## **Baseline Comment Bucket**

# Comment Bucket Buckets

Figure 33-8—PSE detection source

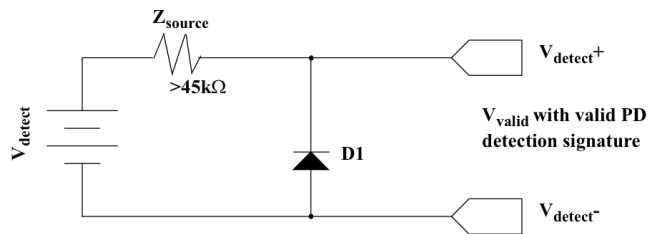
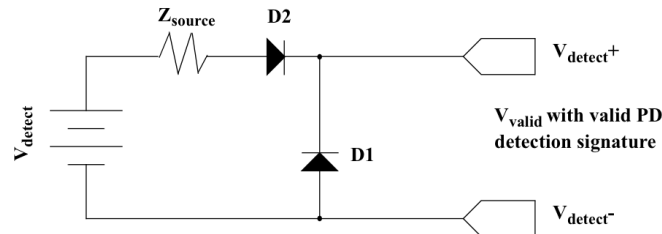
CI 33	SC 2.5.1	P 33	L 51	# 124
Schindler, Fred		Cisco Systems		
Comment Type	TR	Comment Status	D	baseline
<p>The existing section on PD detection requires specific design requirements that are not necessary to ensure interoperability. Other detection methods have been disclosed: <a href="http://www.ieee802.org/3/poep_study/public/sep05/naegeli_1_0905.pdf">http://www.ieee802.org/3/poep_study/public/sep05/naegeli_1_0905.pdf</a> The IEEE specification should ensure requirements for interoperability are in place.</p> <p>This comment also affects text in section 33.3.3, p54, L18.</p>				
<i>Suggested Remedy</i>				
<p>Reference the PD model shown in figure 33-10, and require that the PSE detect values of Rpd_d for all permissible values of Cpd_d as specified in table 33-2.</p> <p>Remove the text requiring two values but continue to provide guidance for designs that use the two probe method.</p>

CI 33	SC 2.5	P 33	L 5	# 13
LANDRY, MATTHEW		SILICON LABS		
Comment Type	TR	Comment Status	D	baseline
A PSE performing detection should be able to provide two characteristics.

(1) Probing into a short circuit won't destroy the PSE or the source of the short.				
(2) Two PSEs probing the same link segment should not result in a 25kohm differential impedance.				
The probing voltage ( $V_{\text{valid}}$ and $V_{\text{oc}}$ ) and short circuit current limit defined in Table 33-2 accomplish (1). A simple shall statement can accomplish (2).				
Instead we have some schematics (Figs 33-8 and 33-9) and a normative statement requiring conformance to them. This sure sounds like mandating an implementation -- and unnecessarily at that.				
<i>SuggestedRemedy</i>				
Strike Figs 33-8 and 33-9 or add a NOTE mentioning that they are informative only.				
Strike Thevenin shall statement on line 45.				
Add the following shall: A PSE shall present a non-valid signature as defined in Table 33-9 in all detection states.				
Note that current PSEs conforming to the Thevenin circuits currently mandated will still satisfy this new shall.
